Access Compliance Report

Public Rights-of-Way

(Curb Ramps)

Intersection ID: 8348	Main Street: LASALLE_ST	Cross Street: TAYLOR_AV	Location: SW
ADA ID: 9E0A2B69E68A	Ramp Type: Perp	Initial Pass/Fail: Fail	Overall Compliance: No
Severity Score: 12.5			
Codes/Mitigation Info/Possible Solution		Field Measurements/Component Compliance

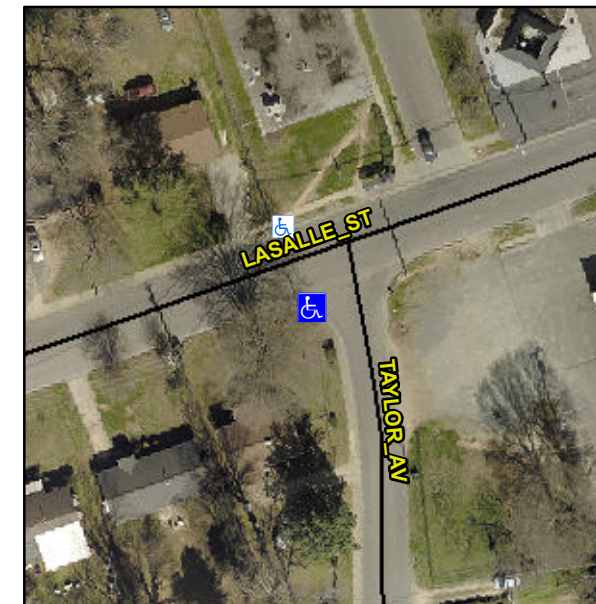
Not Found, R304.2.2

Compliance	Description	Data	Compliance	Description	Data
N/A	Ramp Length (in)	37.0	No	Ramp Slope (%)	11.9
Yes	Ramp Width (in)	72.0	Yes	Ramp XSlope (%)	1.1
N/A	Flare Type LT	N/A	N/A	Flare Type RT	N/A
N/A	Flare Slope LT (%)	N/A	N/A	Flare Slope RT (%)	N/A
N/A	Flare Traversable LT?	N/A	N/A	Flare Traversable RT?	N/A
N/A	Landing Length (in)	N/A	N/A	DWS Provided?	N/A
N/A	Landing Width (in)	N/A	N/A	DWS Contrast?	N/A
N/A	Landing Slope (%)	N/A	N/A	DWS Length (in)	N/A
N/A	Landing X Slope (%)	N/A	N/A	DWS Full Width?	N/A
N/A	Landing Curb? (Y/N)	N/A	N/A	DWS Offset (in)	N/A
N/A	Shared Landing?	N/A			
N/A	Gutter Ponding?	N/A	N/A	Gutter Slope (%)	N/A
N/A	Gutter Lip Ht (in)	N/A	N/A	Gutter X Slope (%)	N/A
N/A	Painted X Walk1?	No	N/A	Painted X Walk2?	N/A
	X Walk 1 Direction	To N		X Walk 2 Direction	N/A
N/A	X Walk 1 Width (in)	N/A	N/A	X Walk 2 Width (in)	N/A
	X Walk 1 Slope (%)	2.8		X Walk 2 Slope (%)	N/A
	X Walk 1 X Slope (%)	2.6		X Walk 2 X Slope (%)	N/A

Remove & Replace Entire Ramp.
